DEPARTMENT OF
ECOLOGY
State of Washington

Second Tier Review Recommendation Document for

**Microsoft Oxford Data Center
Quincy, Washington**

June 13, 2014

Figure 2. Receptor locations in relation to estimated DEEP concentrations (assuming both filterable and condensable fractions represent DEEP). Concentrations are reported as the number of times higher than the ASIL.

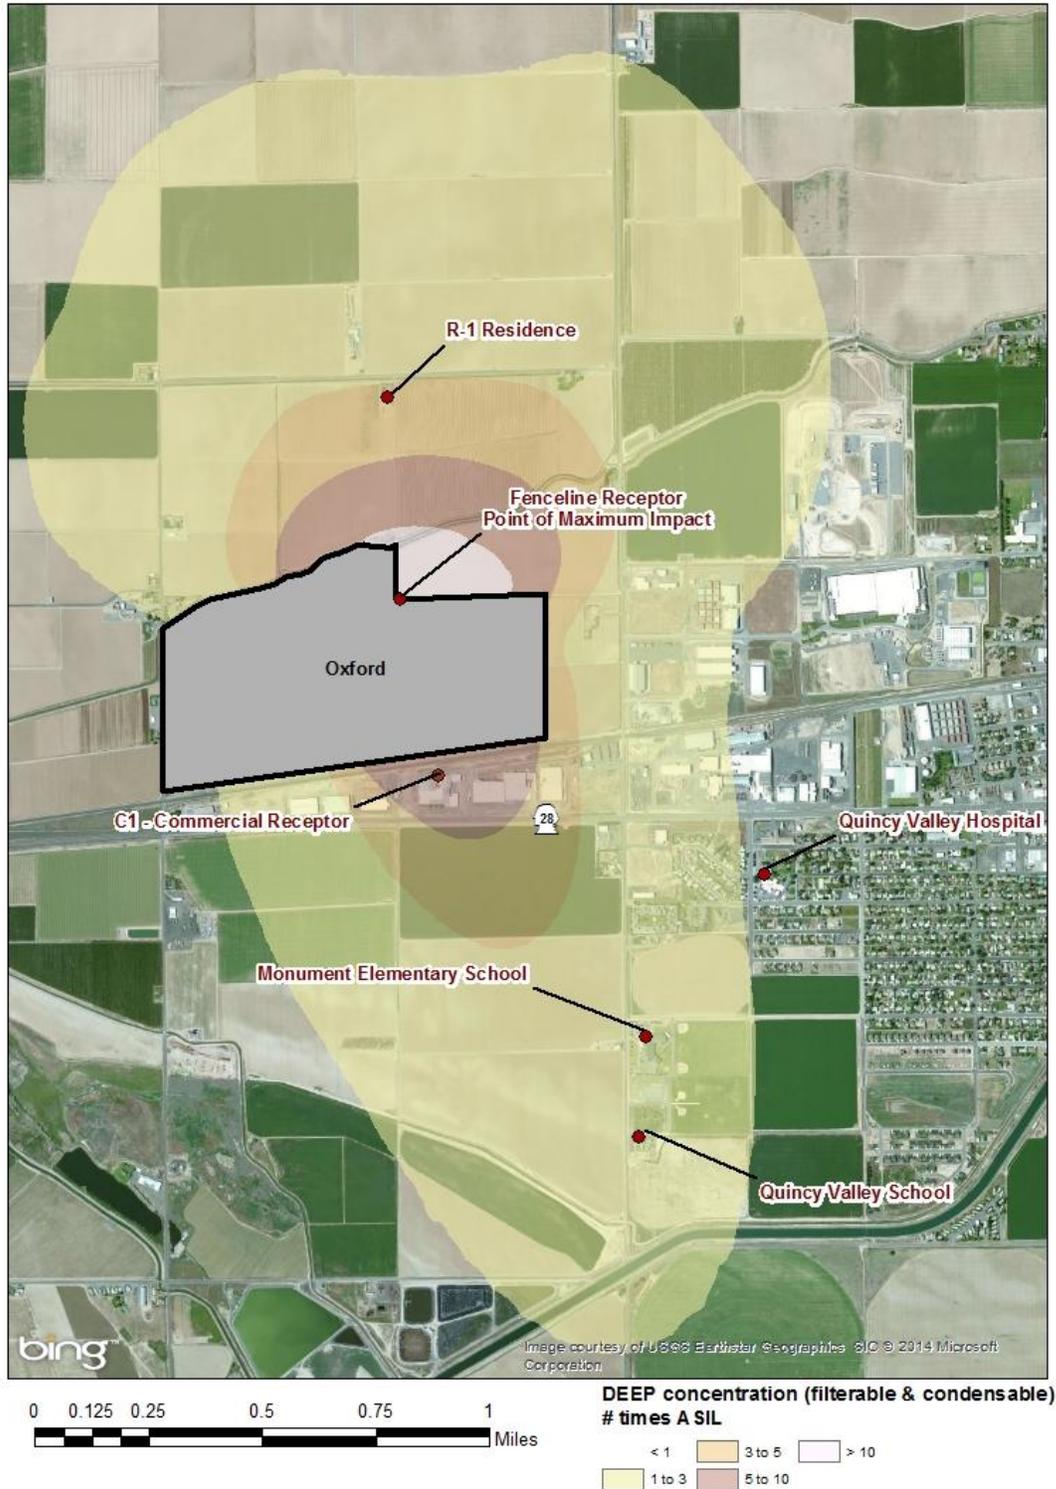
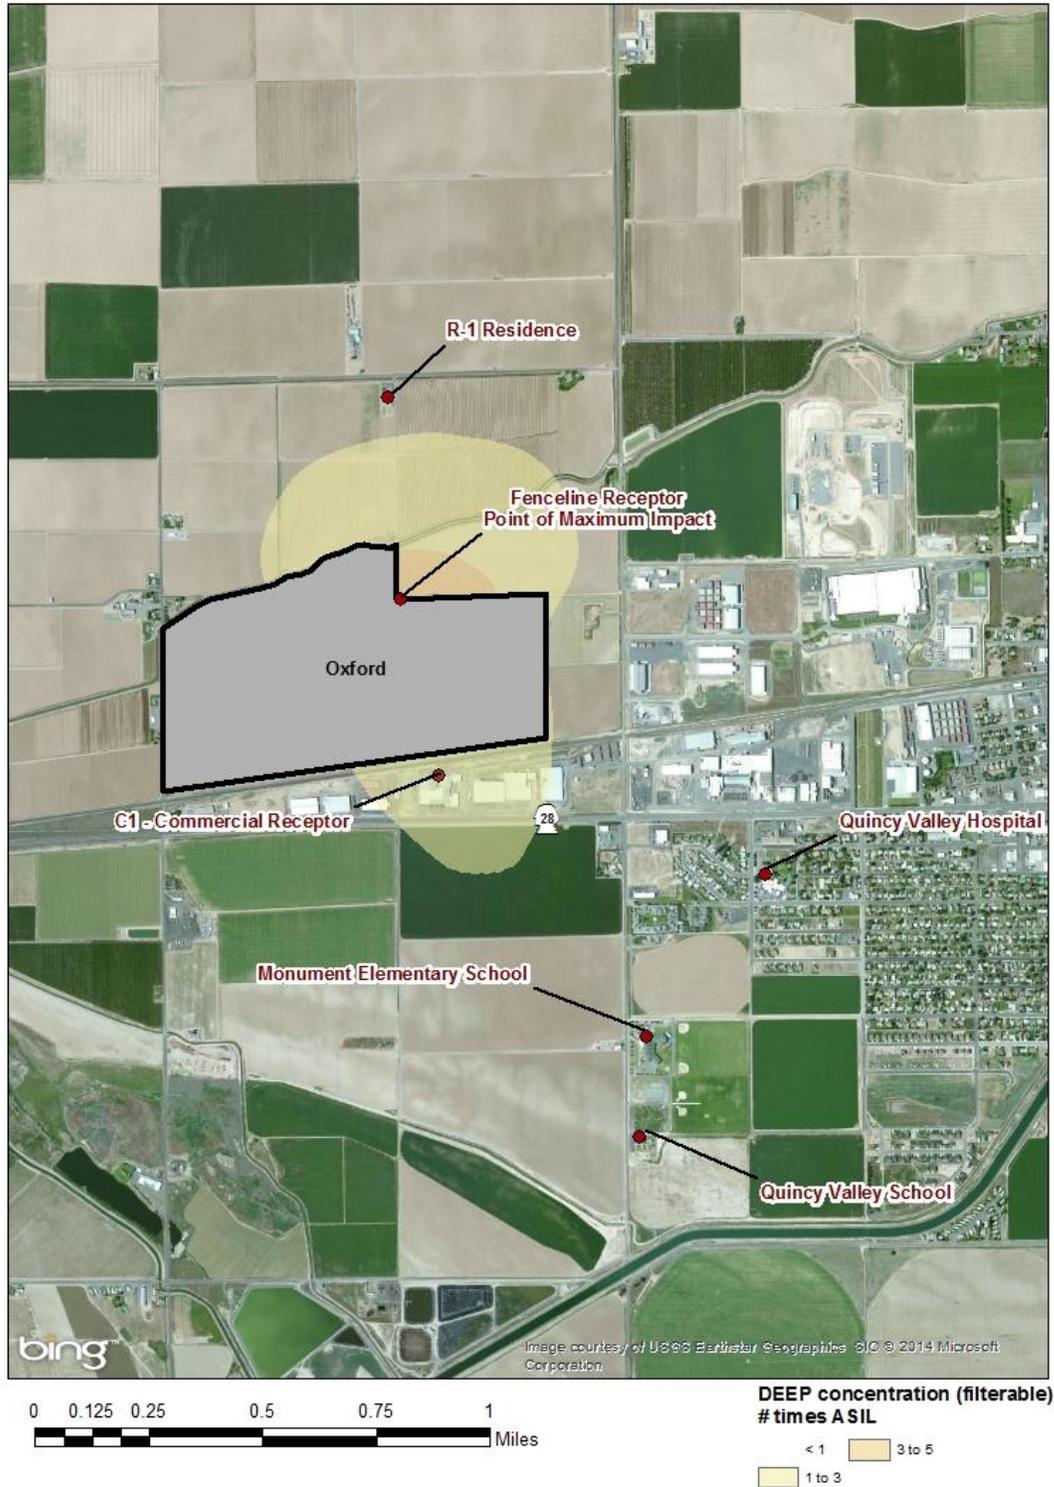
Ecology’s review of the HIA found that Landau identified appropriate receptors to capture the highest exposures for residential, commercial, and fence line receptors. Landau also identified other potential sensitive receptor areas such as students at Monument Elementary and Quincy Valley Schools, and patients at Quincy Valley Hospital (Figures 2 and 3).

Figure 5. Estimated maximum 1-hr NO₂ concentrations resulting from cumulative NO_x emissions of all permitted and proposed data center engines during a simultaneous outage in Quincy. These maximum concentrations do not all occur at the same time.

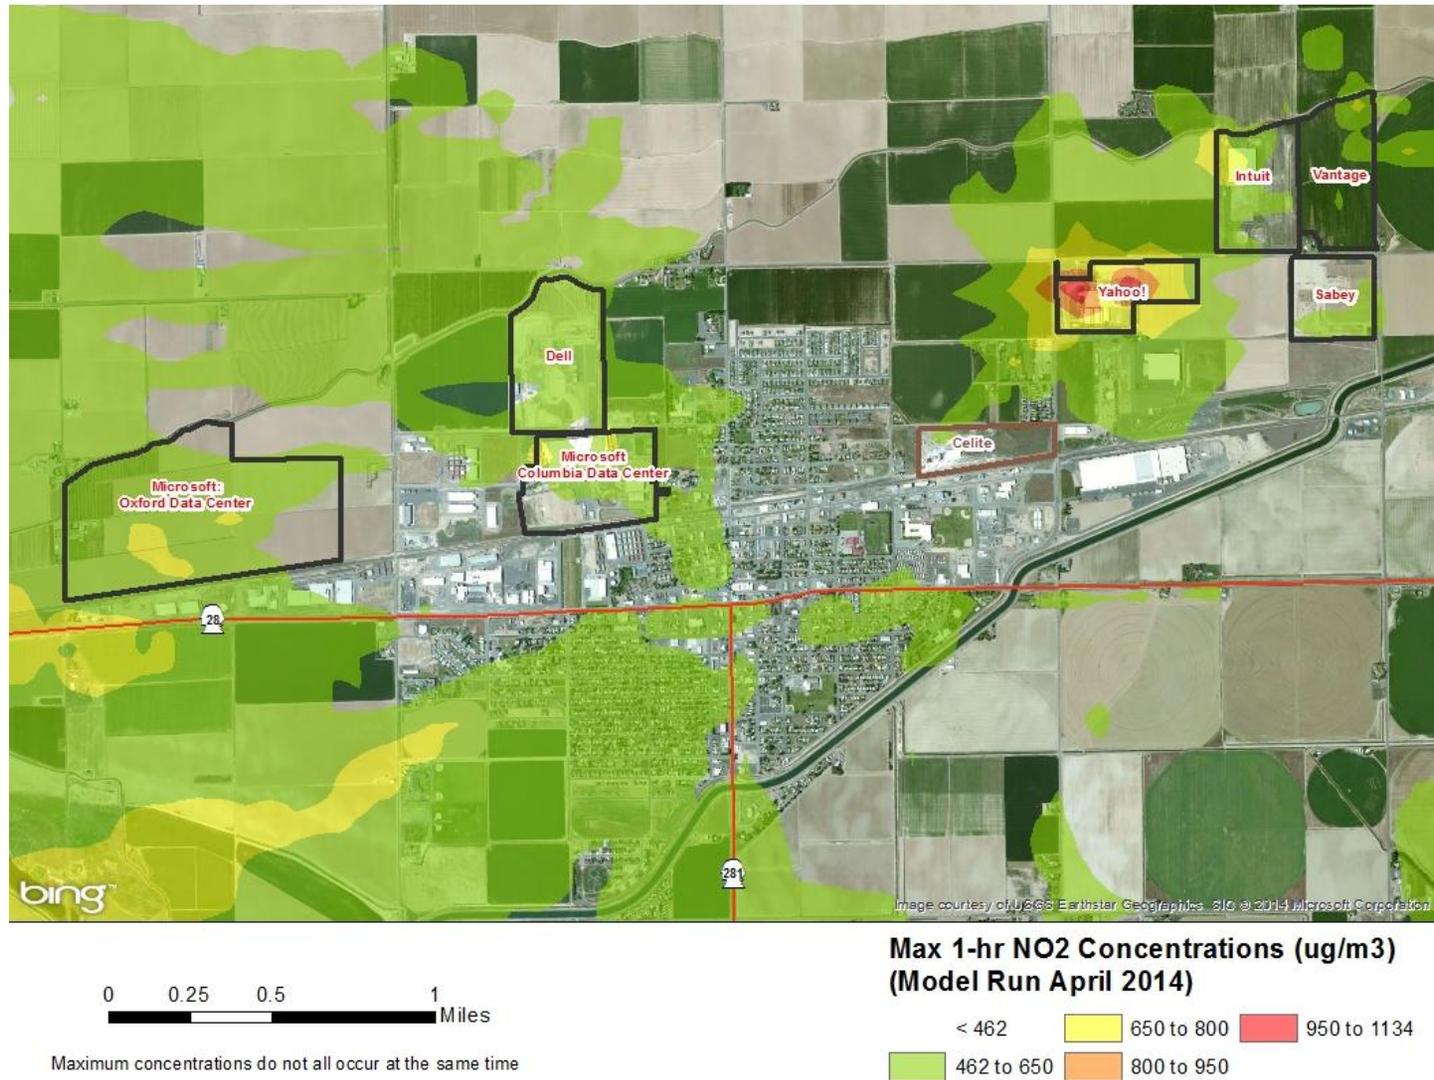
Figure 5 shows the maximum 1-hour NO₂ concentrations that could occur in Quincy if all data centers operated simultaneously under emergency conditions. Although the acute reference exposure level for NO₂ is 470 µg/m³ (CalEPA, 2008), the figure shows only those concentrations that exceed 462 µg/m³ because Ecology assumes that a NO₂ background concentration of 8.3 µg/m³ exists in Quincy at any given time (NW AIRQUEST, 2014). It is important to note that the maximum 1-hour concentrations shown in Figure 5 do not all occur at the same time. The figure displays the worst-case concentration at each location in Quincy. Generally, this figure shows that concentrations of NO₂ could exceed a level of health concern in some areas of Quincy.

Figure 6. Estimated number of times per year that 1-hr NO₂ concentrations could exceed 462 ug/m³ assuming continuous outage emissions for an entire year.

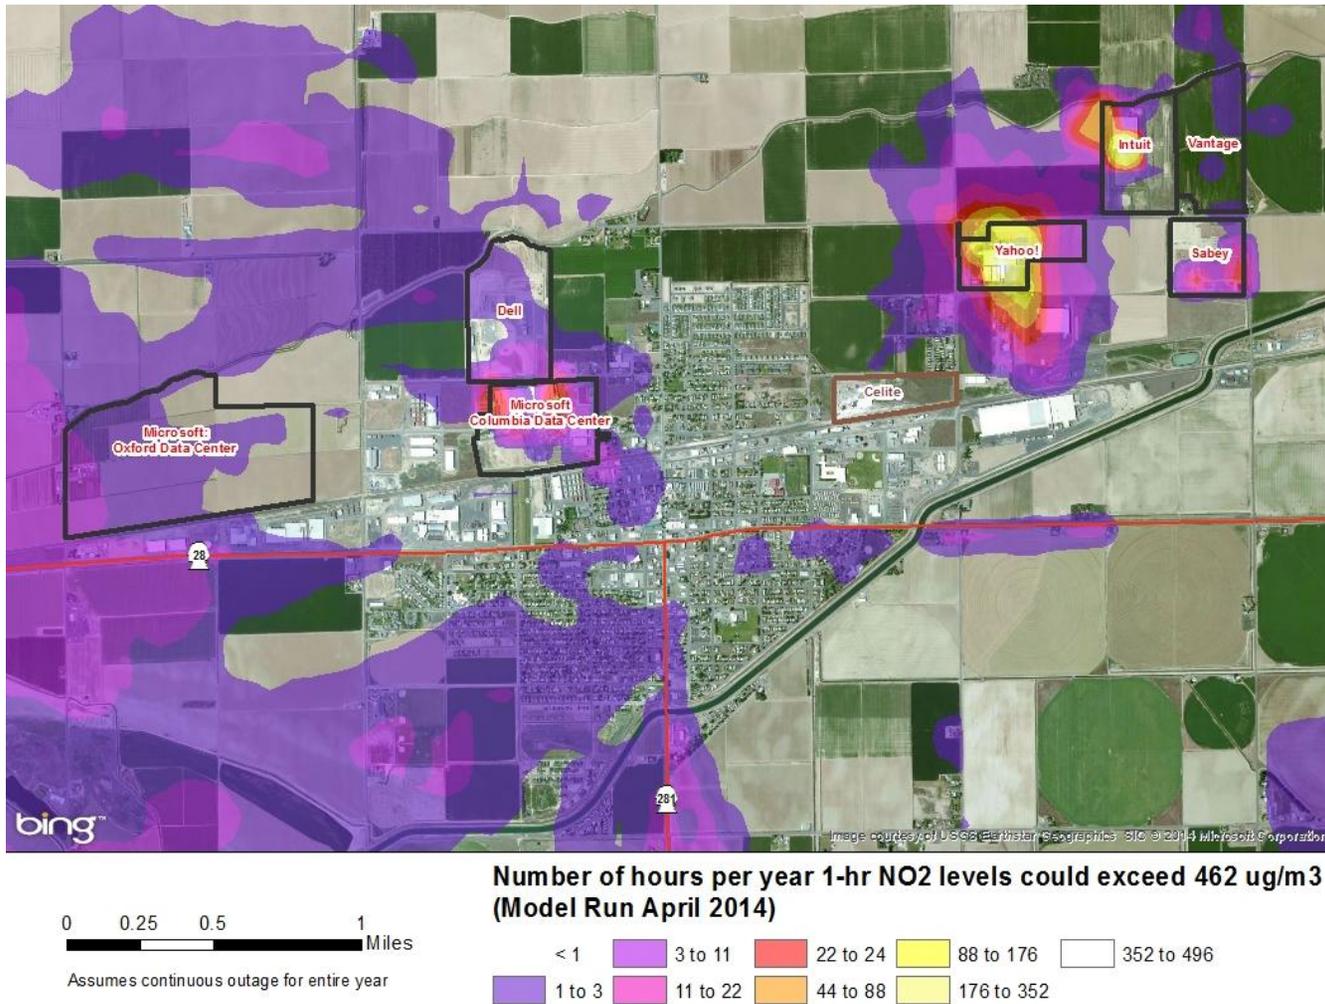
Ecology also analyzed the frequency (# of hours per year) meteorological conditions could result in a NO₂ concentration greater than 462 µg/m³ at each receptor point within the Quincy modeling domain. Figure 6 shows the number of hours per year that a cumulative NO₂ concentration could exceed 462 µg/m³ assuming data center engines operate during all combinations of meteorological conditions experienced throughout the year. If engines were run continuously during the course of a year, some areas near data centers could achieve concentrations of health concern for up to about 300 hours per year. In reality, these data centers were not permitted to continuously operate their engines; instead, they are only permitted to operate between eight and 400 hours per year under emergency outage conditions. Grant County Public Utilities District (PUD) reported that from 2003 to 2009, the average total outage time for customers that experience an outage throughout PUD's service area is about 143 minutes per year (Coe, 2010).
